Interactive comment on “Conceptual and numerical modeling of the Guaraní Aquifer System” by L. Rodríguez et al.

L. Rodríguez et al.

Received and published: 12 September 2012

Fig. 1.

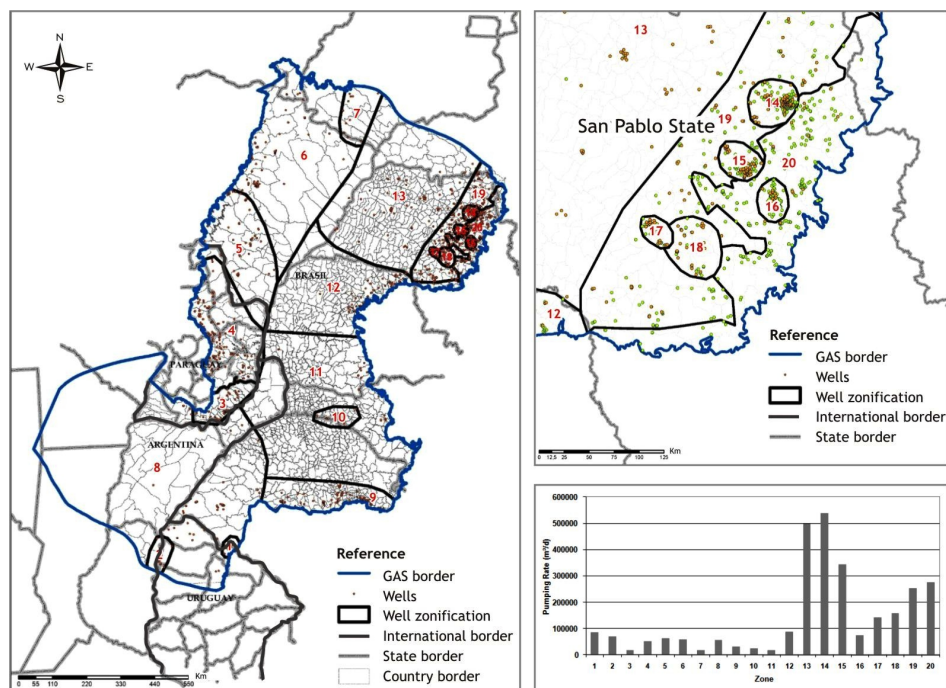
5) Showing the spatial distribution of pumping would be instructive to the readers.

Having said all this, we address each of the questions pointed out by the reviewer. We also attached a draft figure for pumping distribution.

We uploaded a draft figure with this information that will be incorporated in the final version of the manuscript after the discussion period ends.
